ANALYSIS

FASHION ROW
HALLANDALE BEACH, FL
CONCEPTUAL STREETSCAPE PLAN

The City of
HALLANDALE BEACH
DEPARTMENT OF PUBLIC WORKS
OFFICE OF STREETSCAPE DESIGN

Item 1:

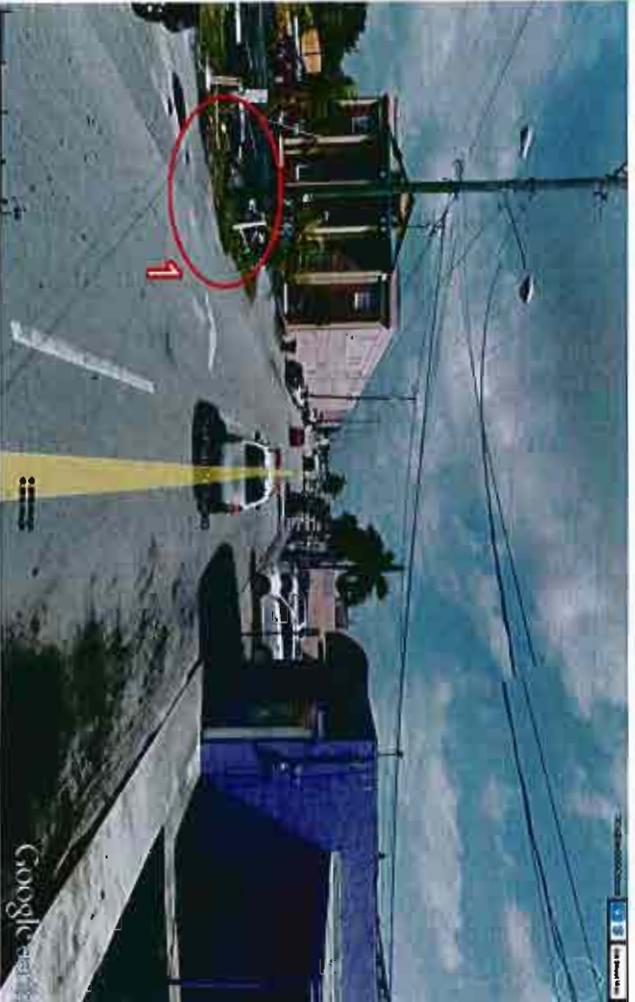
The City-originated engineered design improvements around existing utility poles to remain. The utility poles are not presently located on the outside edge of the public's ROW, but are offset into the ROW at varies offsets. These provide clearances between the outside boundary of the ROW and the face of the utility pole that vary from 2.96 feet to 4.9 feet, as determined from the provided Cad base file. At times abutting improvements in the private properties may restrict the minimum clearance of 3.0 feet required by ADA standards.

- A. Conduct an in-field assessment to ensure that all areas where existing utility poles exist adequately provide the minimum clearances required to meet ADA standards.
- B. Make notations on the construction plans to ensure that the contractor provides a minimum of a 3-foot clearance to meet ADA requirements.

Item 2:

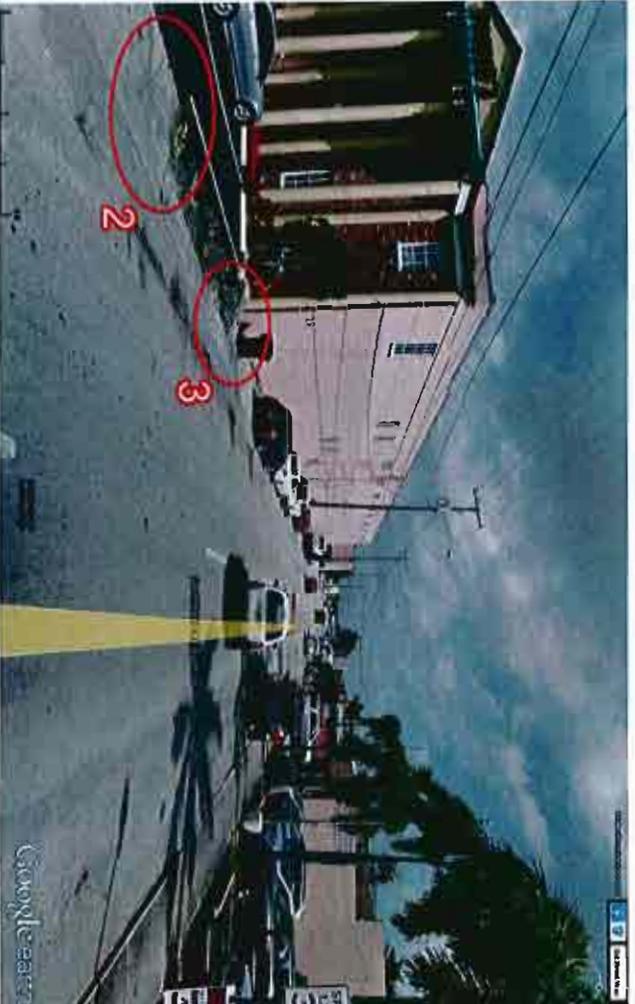
The City-originated engineered plan proposes improvements that are in conflict with the existing elevations of present on-site. The engineered plans propose a 6 foot wide sidewalk be installed abutting the edge of the ROW, which coincides with the edge of the building's street-facing facade. The proposed sidewalk on the plans does not indicate any running-slope pitch to meet the existing grade of the building's parking lot, which is estimated at approximately 12-14 inches above the finish grade of the abutting asphalted edge.

Similar to the issue in Item 2, there is a drop-off between the finish grade of the parking lot at the building's edge, which is approximately 14-18 inches above the finish grade of the asphalted area.

- C. Provide a topographical to better determine the elevation constraints and drainage patterns on-site
- D. Raise the sidewalk elevation as it approaches the parking lot entrance so as to ensure that the cross slope of the proposed sidewalk does not exceed the 2 percent cross-slope maximum allowed by ADA standards.

- E. Because the distance to obtain the necessary elevation rise in the sidewalk is very short immediately south to the area encircled as "2", it may be necessary to utilize an ADA ramp design with a maximum slope 8.33% with handrails, otherwise we recommend providing access ramps at a maximum of 4.5% (allowing for construction error) to minimize on the need of having to provide handrails and any limitations on lengths of slope runs.

- F. Where abutting elevation changes exceed 18" within a 3-foot buffer of the ramp/slope, handrails should be provided so pedestrians do not fall into the adjacent proposed travel lane.

Item 6:

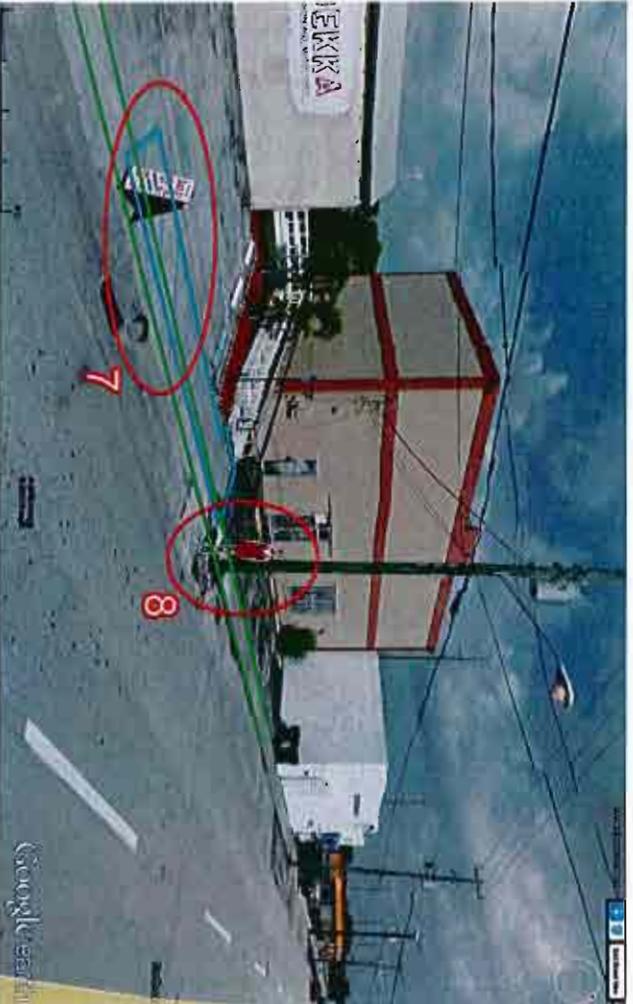
The City-originated engineered plan proposes the installation of a 6-foot wide sidewalk along the outermost edge of the ROW (shown in green). Presently, this area is being utilized by several properties as the location for their 90-degree, pull-in parking. In several of these situations, the designs of the parking stalls meet the dimensional design standards at a minimum and at times are sub-standard. By providing a sidewalk in this location, already-challenged parking areas will be rendered sub-standard, and the proposed sidewalk will invariably be obstructed by parked vehicles.

- G. As a first step, the land development regulations should assess the need that requires each property to provide a minimum number of parking spaces, and what those minimum parking spaces requirements should be. Otherwise conflicts in the proposed improvements, both in the short-term and long-term realms will be most challenged by parking requirements. There may be a need to lessen the number of parking requirements, at a minimum meeting the needs of ADA Standards.
- H. The City should conduct a short-term and long-term parking study to determine the feasibility of shared parking standards throughout the roadway segment coupled with parking count improvements provided by the City throughout the ROW or elsewhere in the immediate, walkable vicinity.

Item 8:

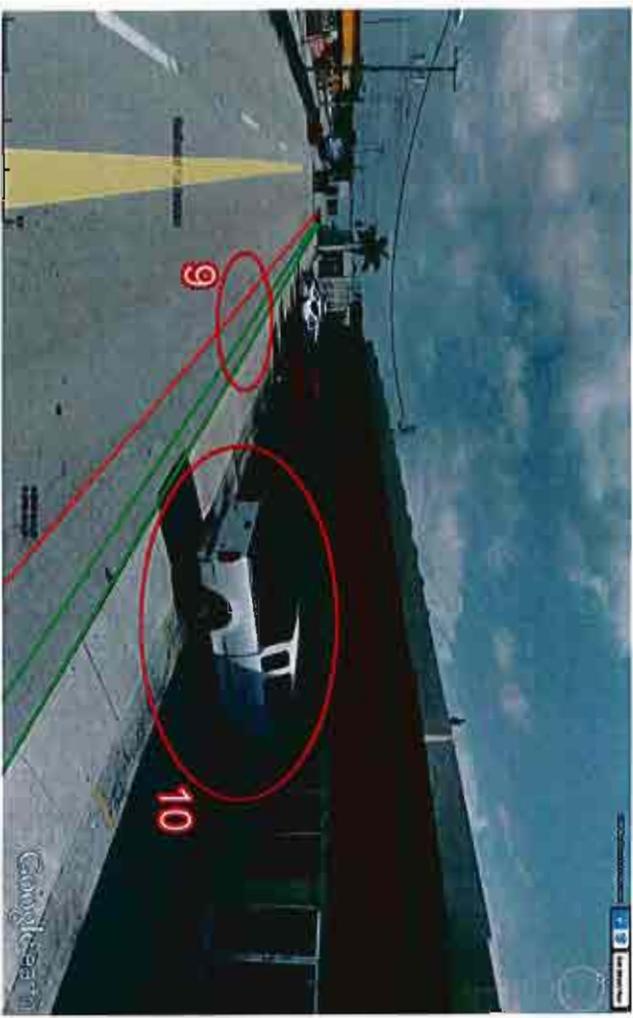
Similar to the parking conflicts in Item 6, the City-originated engineered plan proposes the continuation of a sidewalk alongside the edge of the ROW. At times, the conflicts with the existing improvements may not only be of a spatial, site design one, but they also provide aesthetic implications. As an example, the area outlined in blue identifies the existing ADA access route from the ADA parking space to the access ramp. By code, this route has to be striped and marked with blue indicators lines in accordance to design standards established by the ADA code. The area shown in green illustrates the location of the proposed sidewalk, which is envisioned to be paved with a branding paving design. In order to meet code, the blue striping will have to be installed on top of the paving design, which will create an aesthetic conflict to the 'look' and 'finish quality' of the environment. This situation will be typical at all locations where the proposed paved sidewalk will conflict with any parking's striping.

The City-originated engineered plan proposes a 16-foot wide travel lane immediately abutting the edge of the sidewalk. We have concerns about this design and potential safety considerations for both pedestrians and drivers – considerations that may put the City at a liability risk. In essence the problem is two-fold:

- Pedestrians will be walking on a sidewalk that is flush with and immediately adjacent to the roadway. There are not mechanisms in the design plan to ensure that if a vehicle veers from their path that the pedestrian will be protected.
- Immediately along the edge of the travel lane, vehicle will be confronted with existing utility poles with no mechanism to prevent a vehicle from crashing into them

1. The posted speed limit is currently at 30 mph. The city should make every attempt to further reduce the speed limit.
- J. The travel proposed lane should be reduced from 16-feet to 12- feet wide, or even 11-feet if possible.

- K. Once the travel lane has been reduced, the remaining 4 or 5 feet of asphalt (depending on the width of the travel lane) between the travel lane and the sidewalk and poles should be treated as a 'warning strip'. This warning strip should be colored and textured so if a vehicle veers off of the travel lane there is every attempt made to alert the driver to prevent any impact to pedestrians or utility poles.

- L. As an added caution, a collar curb should be provided around the bases of all existing utility poles to protect vehicular drivers from accidently having a collision with the poles.

- M. Where possible and where parking/driveway access is not needed, the City should provide bollards alongside the edge of the sidewalk in the 'warning strip' area to provide as much protection for pedestrians on the sidewalk.
